ADDENDUM NO. #0

TRACK & FIELD IMPROVEMENTS

LITTLE JOB #612-12353-06

Oxnard High School

C4.2 AD0-C9

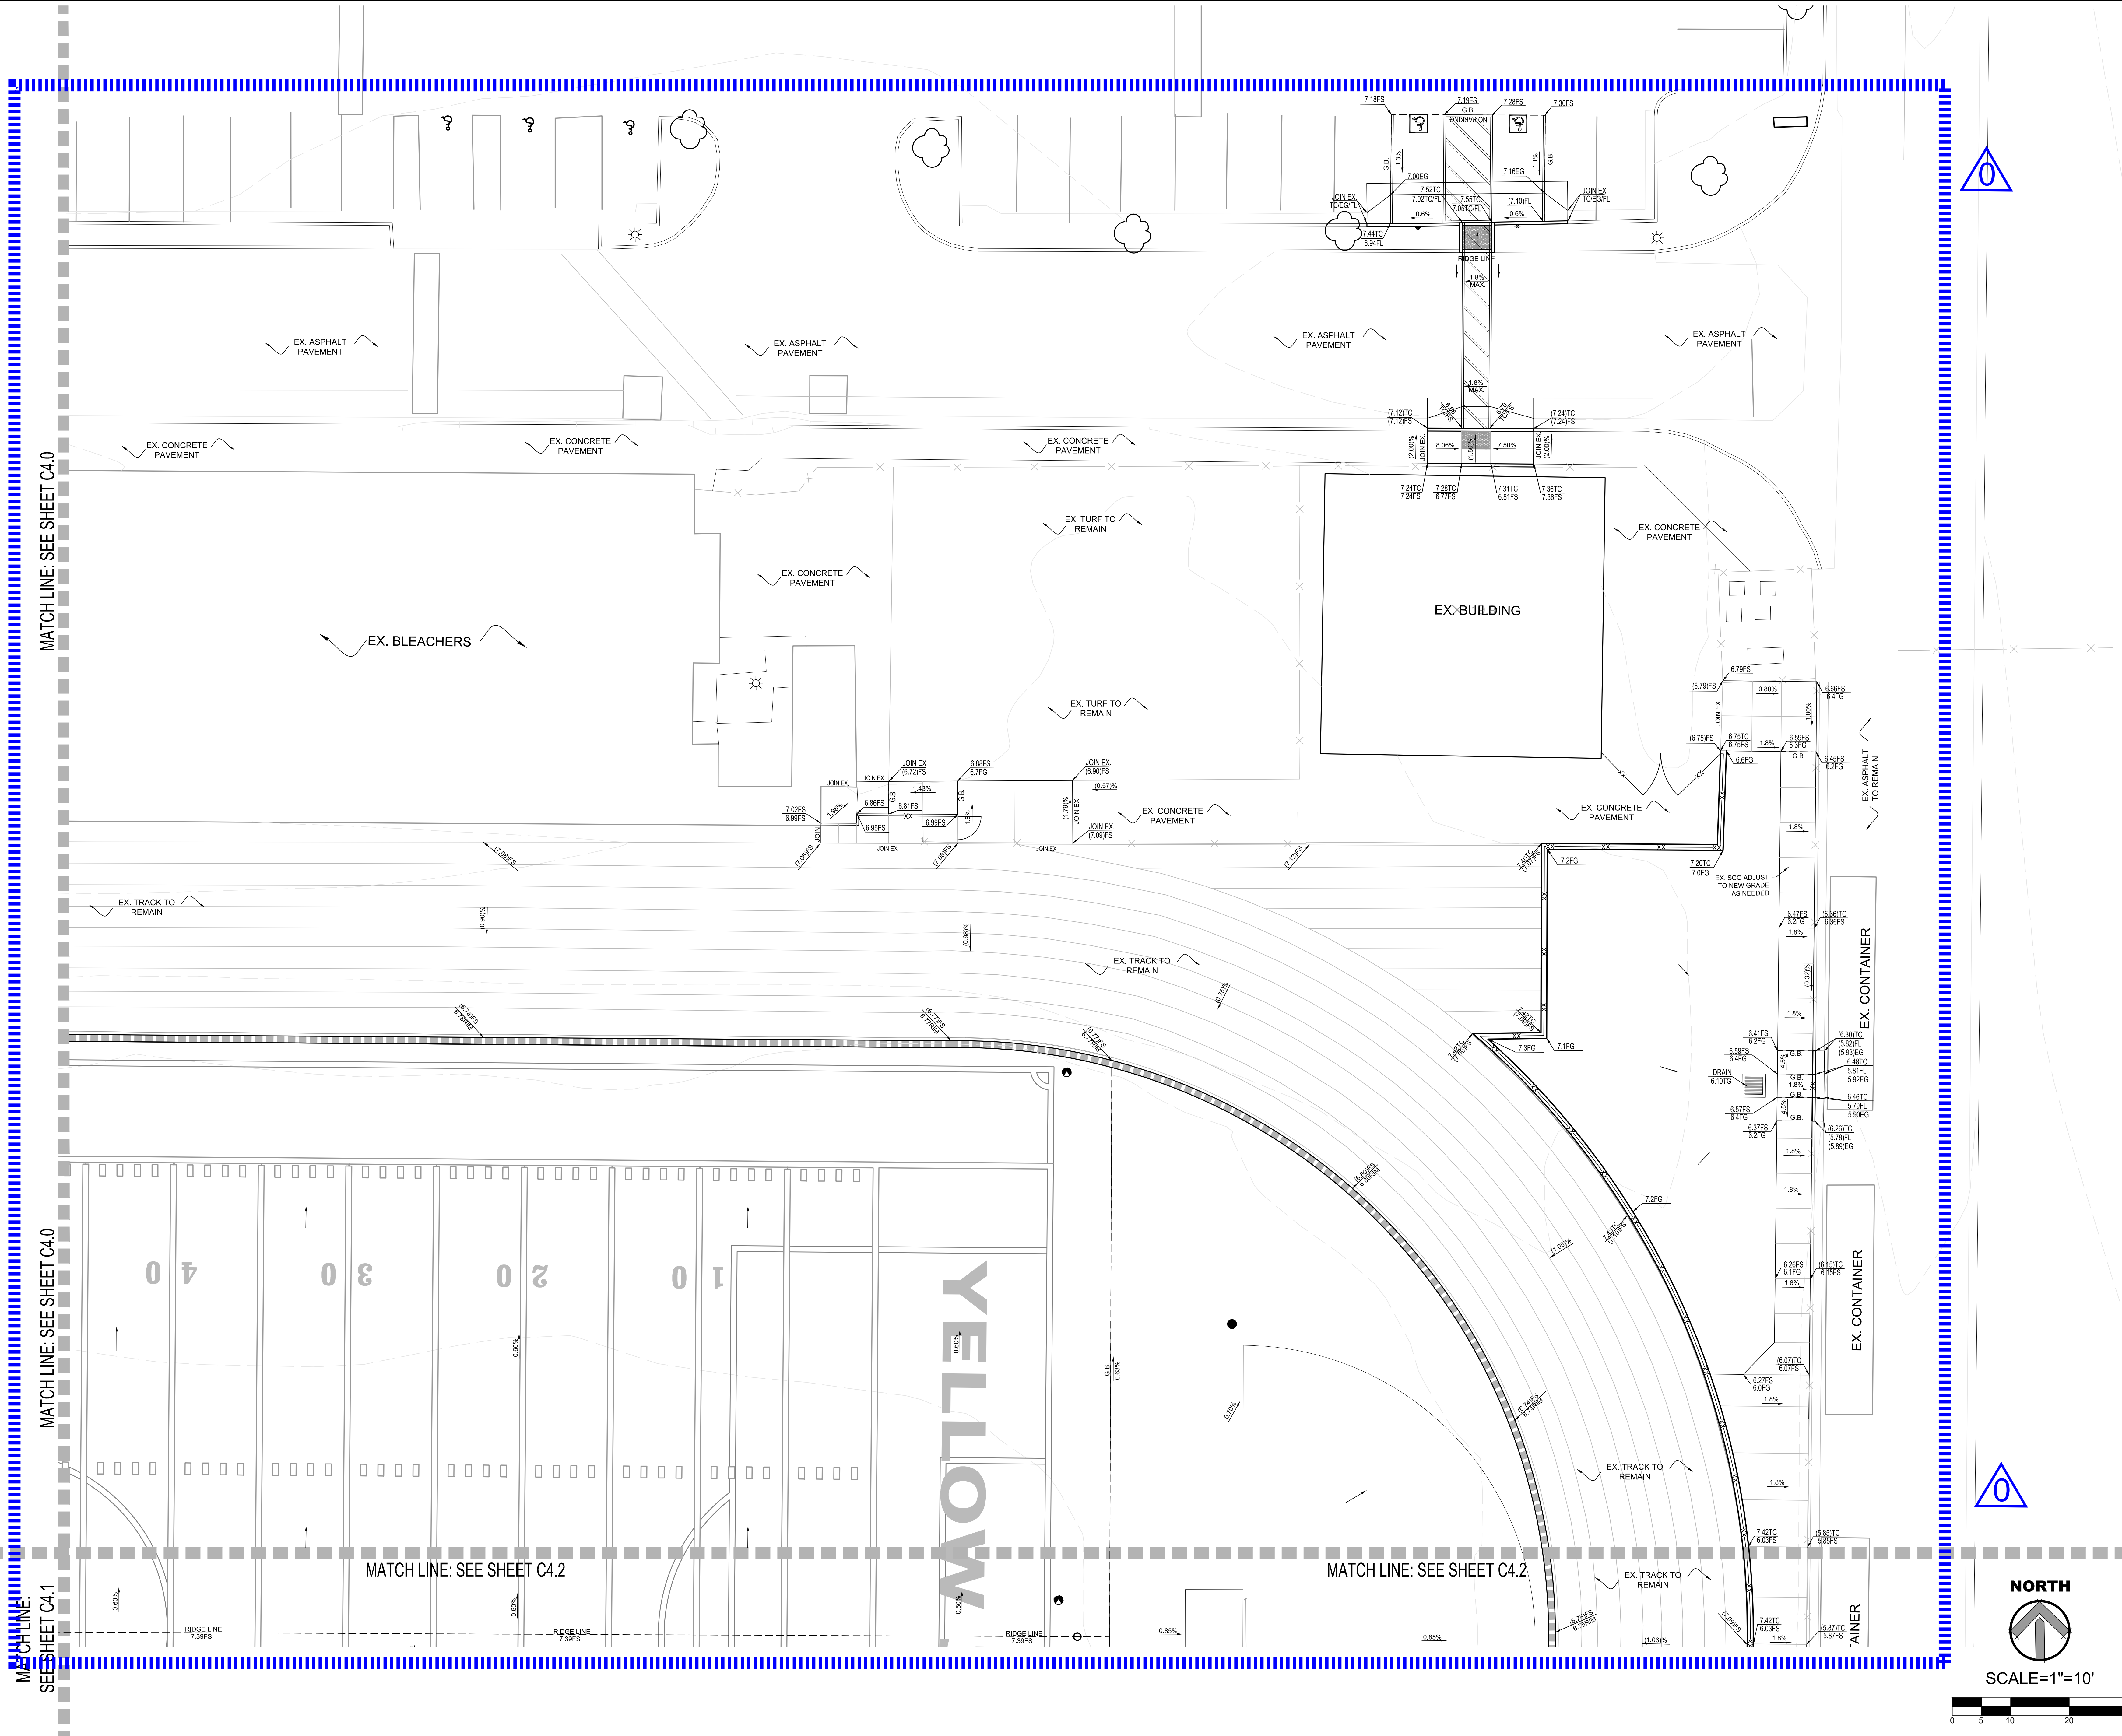
- 3.1.2.9.** Drawing C4.2/AD0-C9 - Only work within outlined area is included in scope of this project and bid. Any work shown outside of the delineated area is not part of this project. Also, we have included a note on plan requiring contractor to gently transition from new improvements tying back to existing improvements via transitional AC paving (3" thick). Directional slopes shall not exceed 4.9% and also cross slopes shall not exceed 1.8%.

furnish and install temporary transitional AC paving (3" thick) to tie into existing surrounding improvements. (directional slope 4.9% max and cross slope 1.8% max)

C4.3 AD0-C10

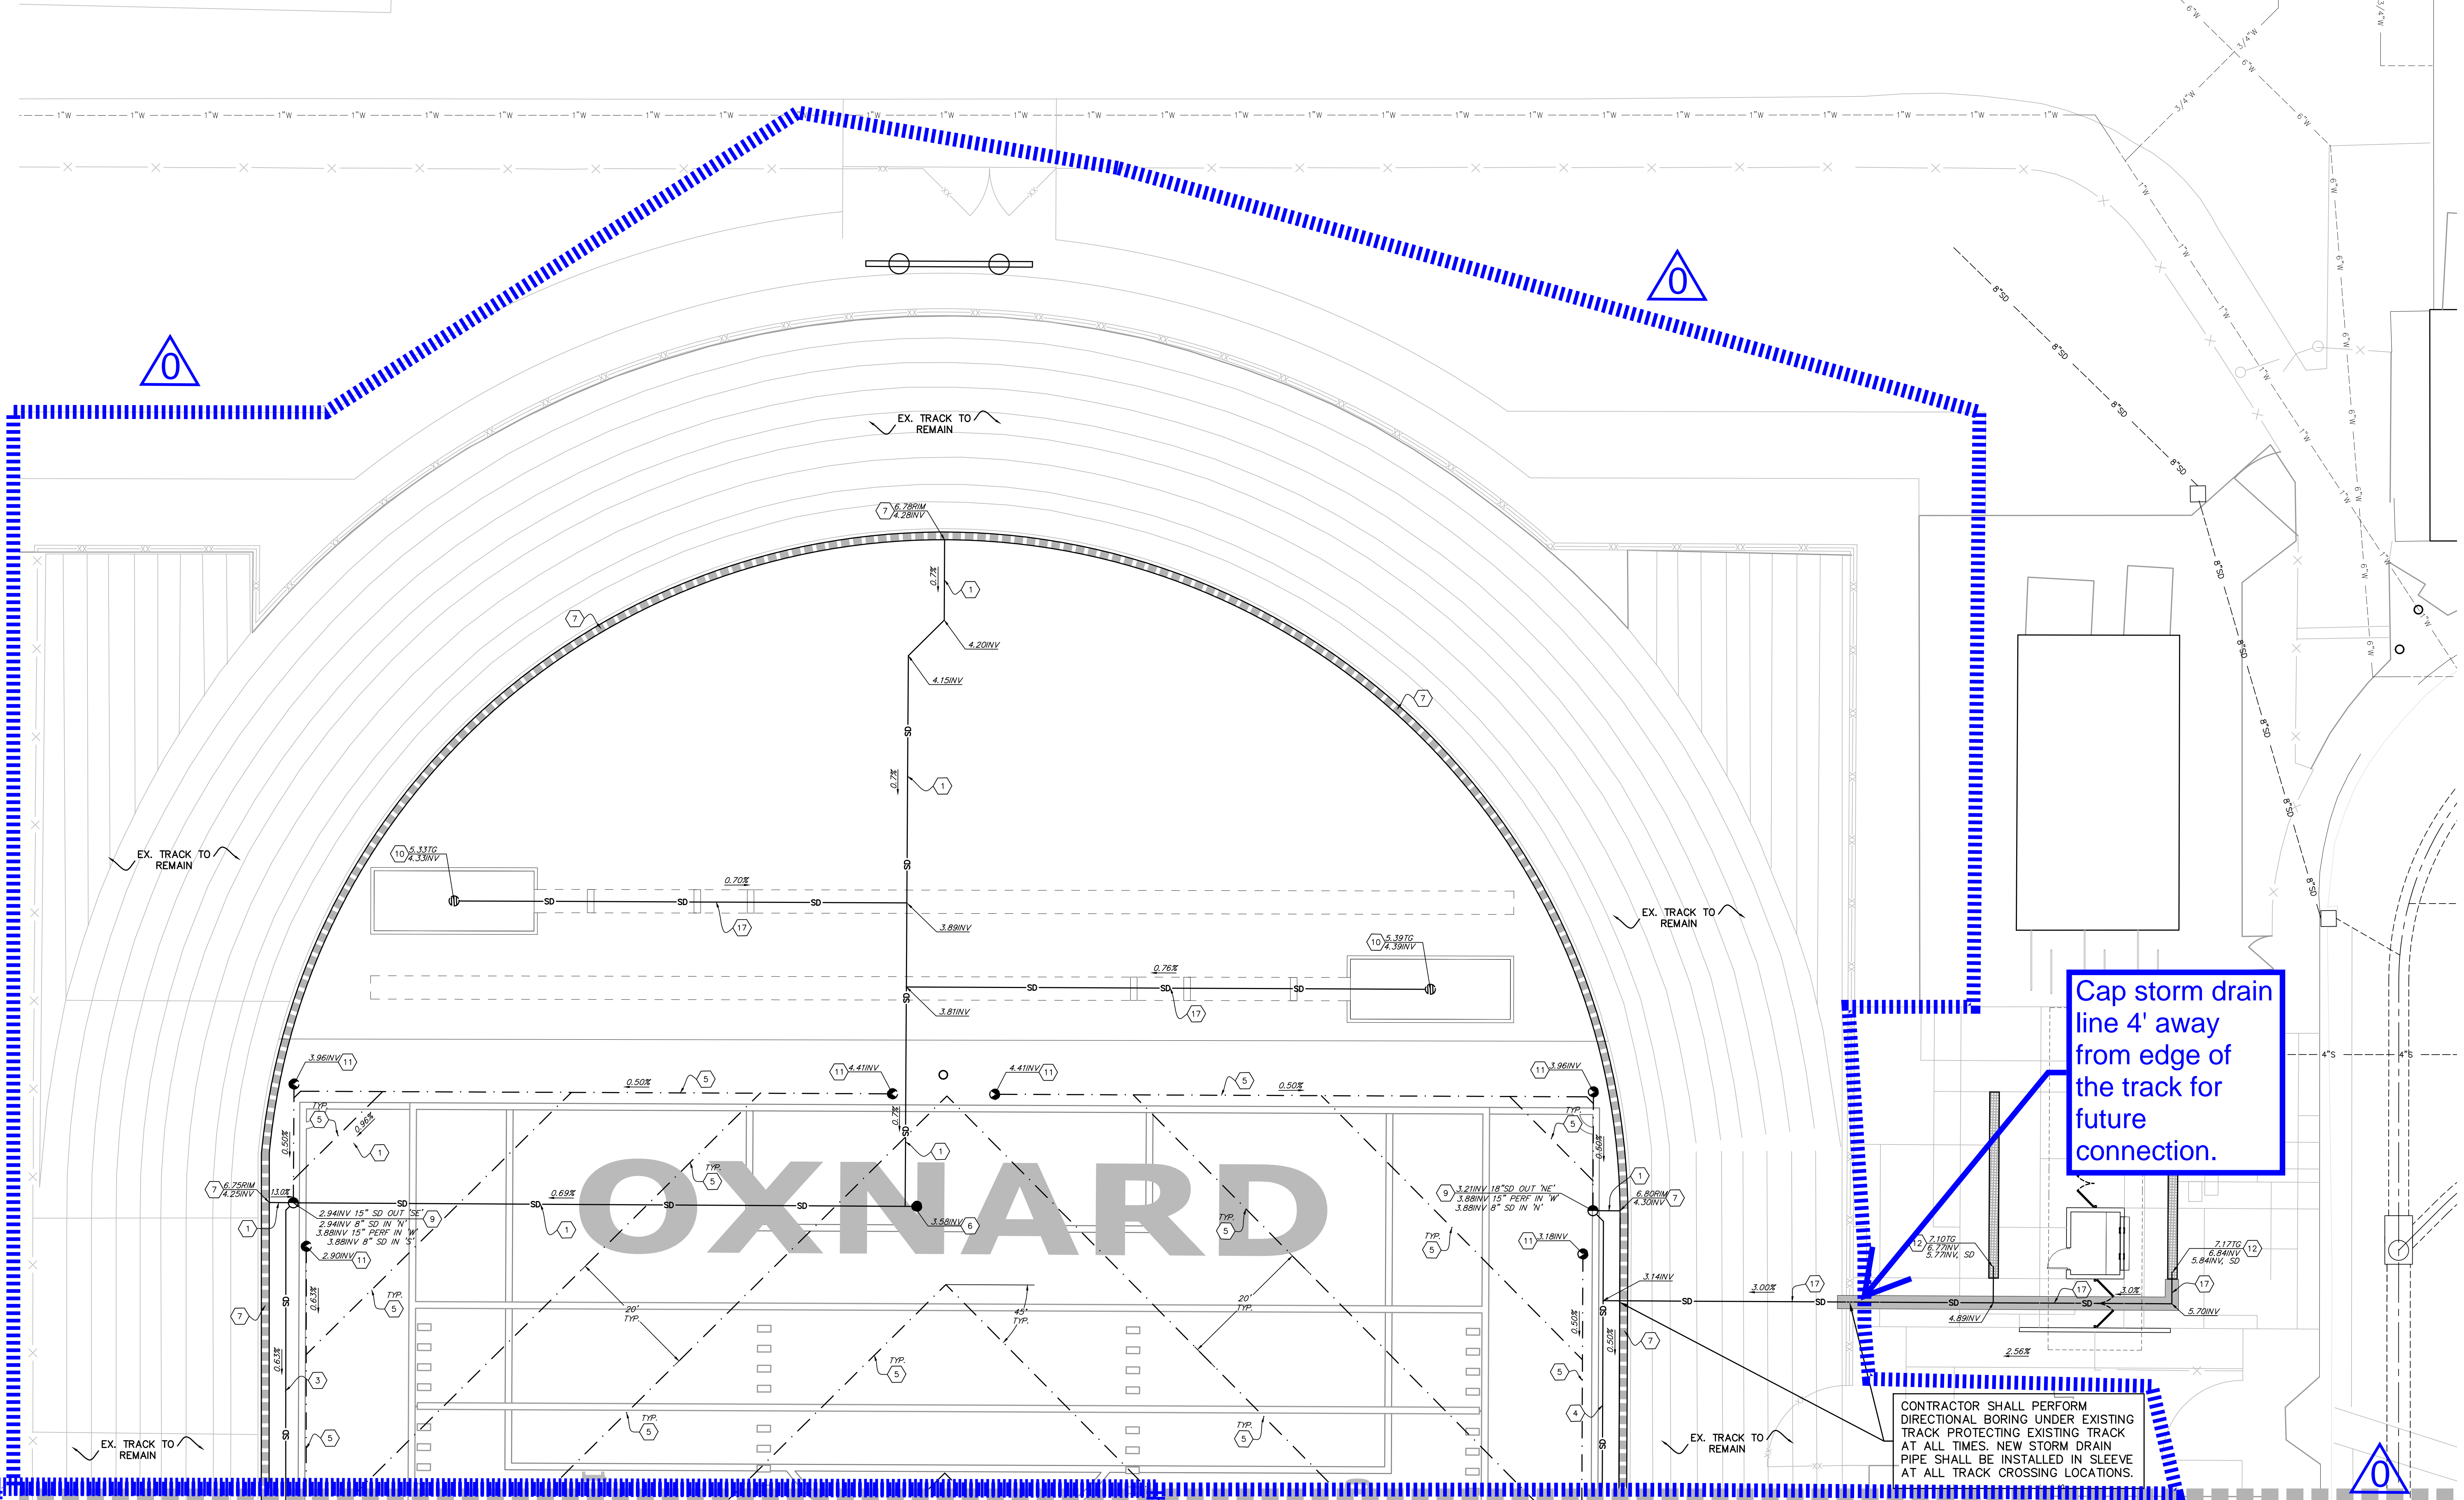
- 3.1.2.10.** Drawing C4.3/AD0-C10 - Only work within outlined area is included in scope of this project and bid. Any work shown outside of the delineated area is not part of this project.

C5.0 **AD0-C11**

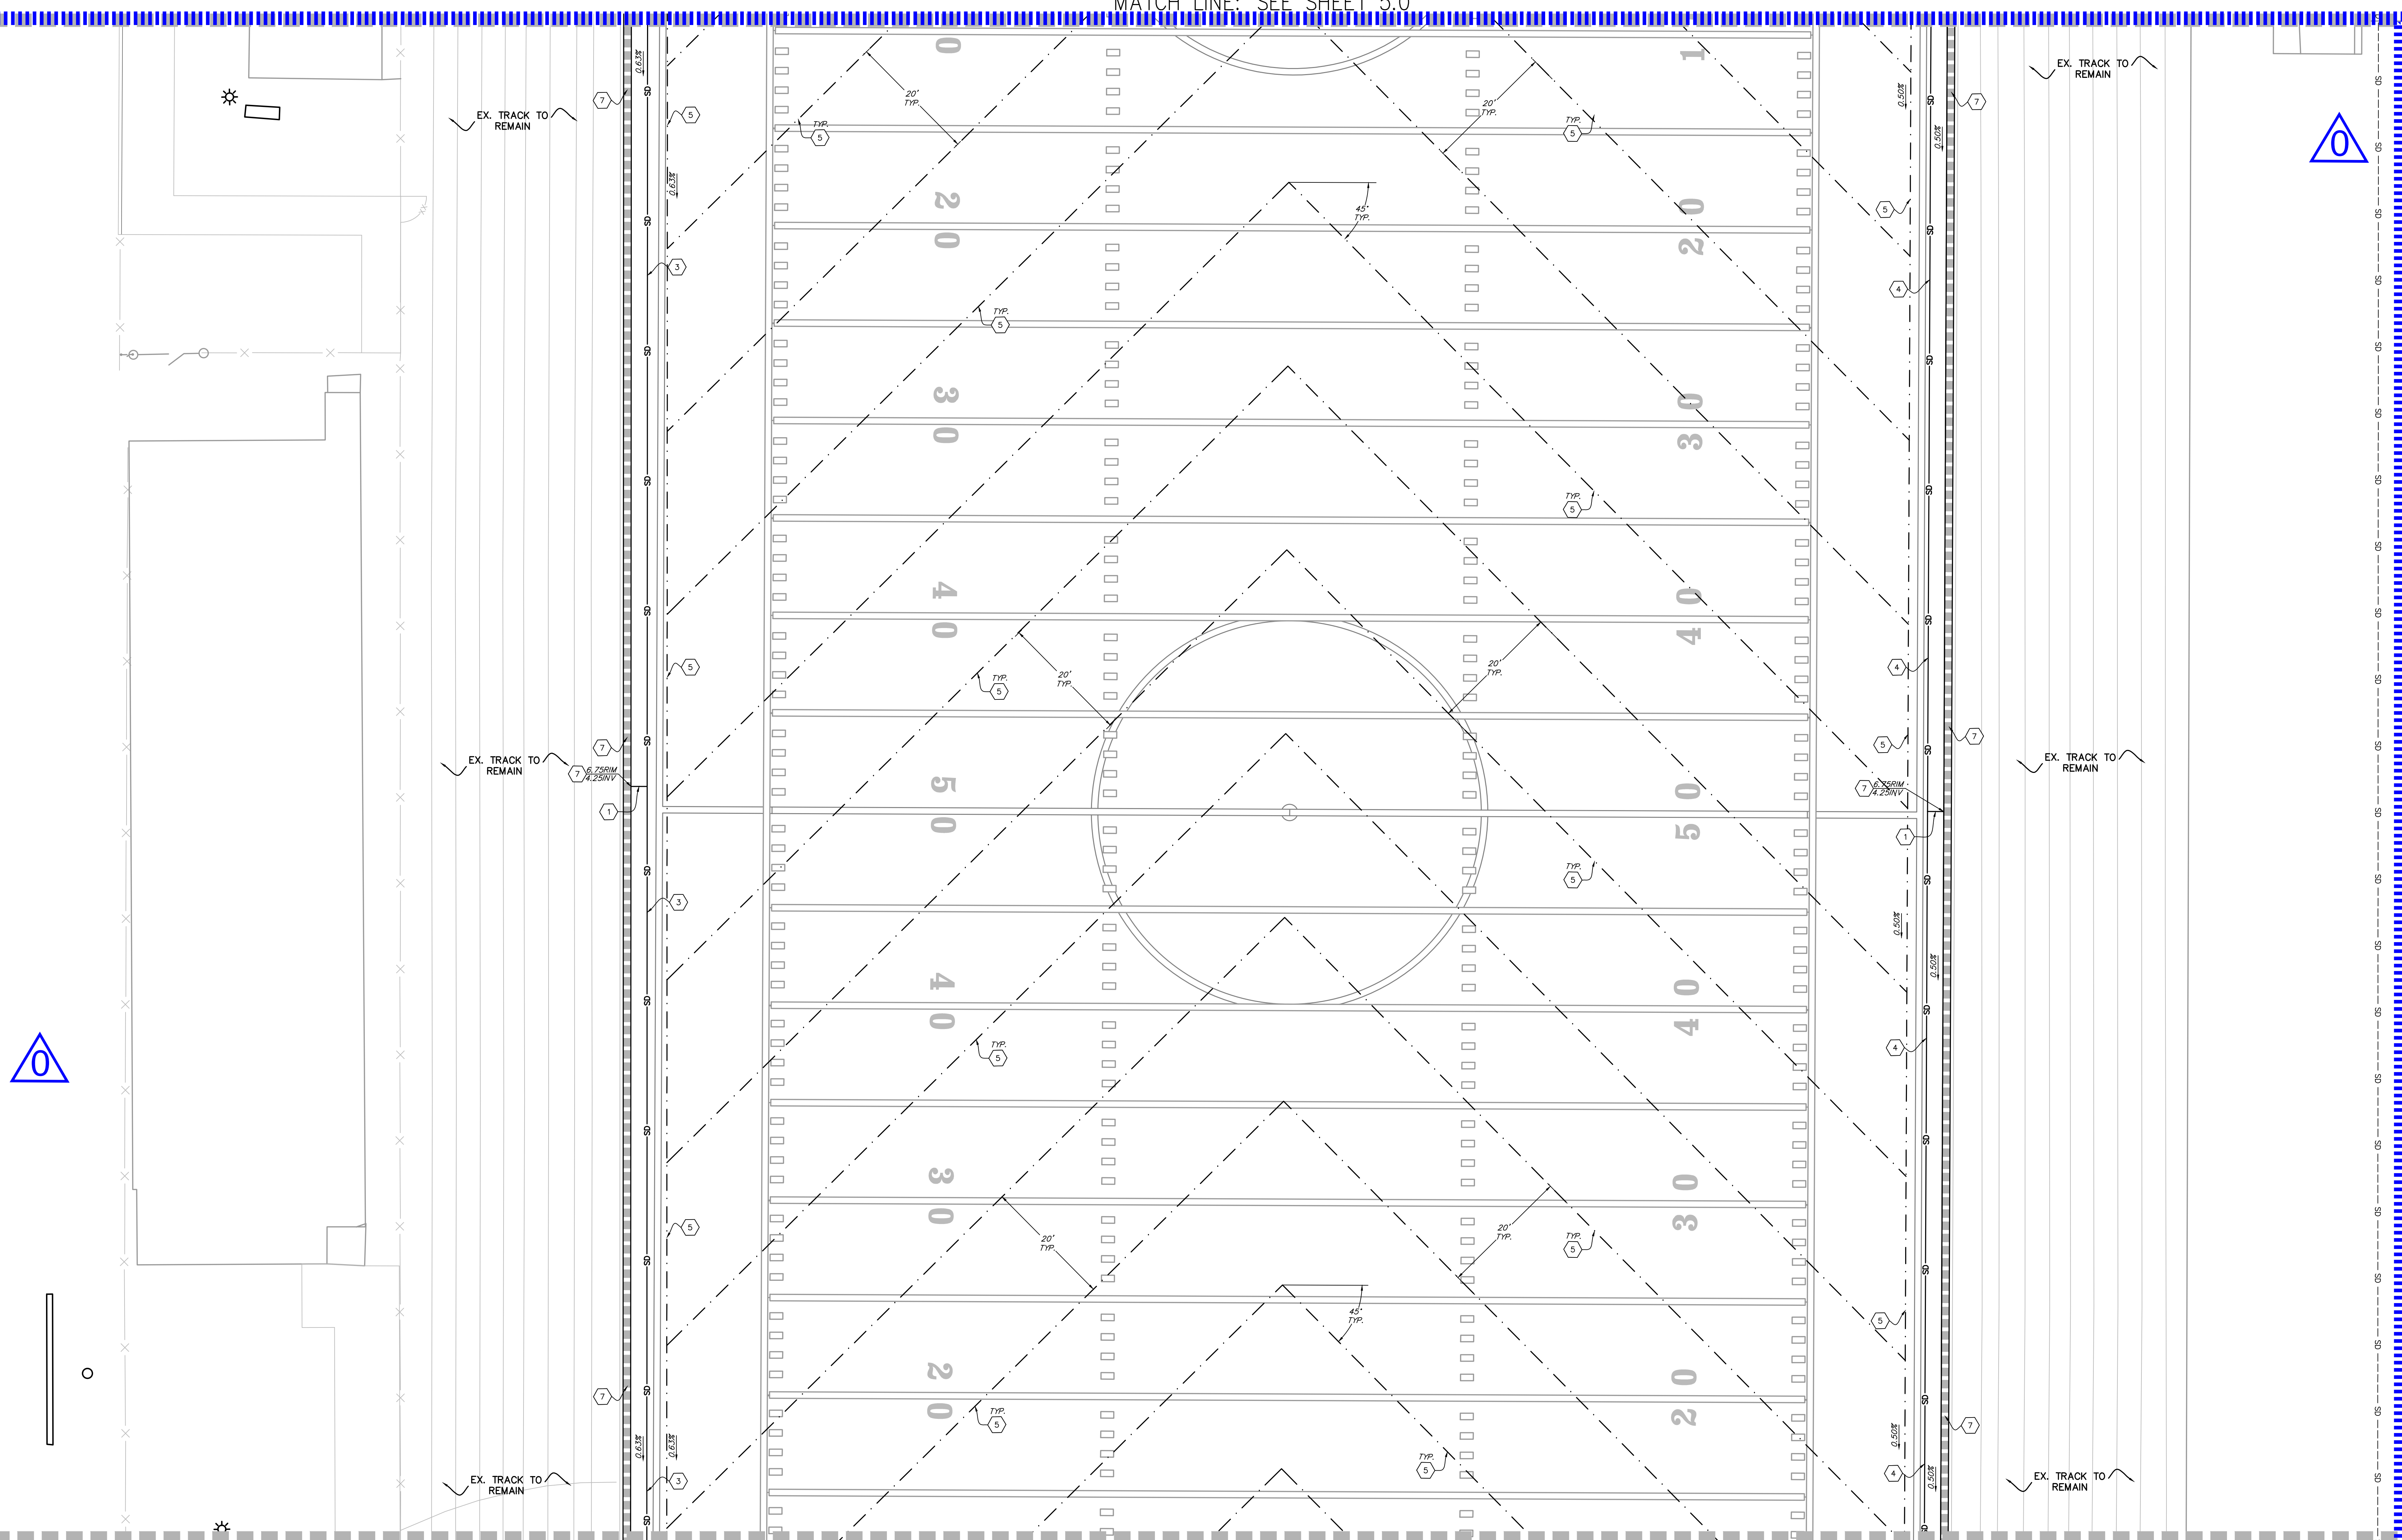
- 3.1.2.11.** Drawing C5.0/AD0-C11 - Only work within outlined area is included in scope of this project and bid. Any work shown outside of the delineated area is not part of this project.
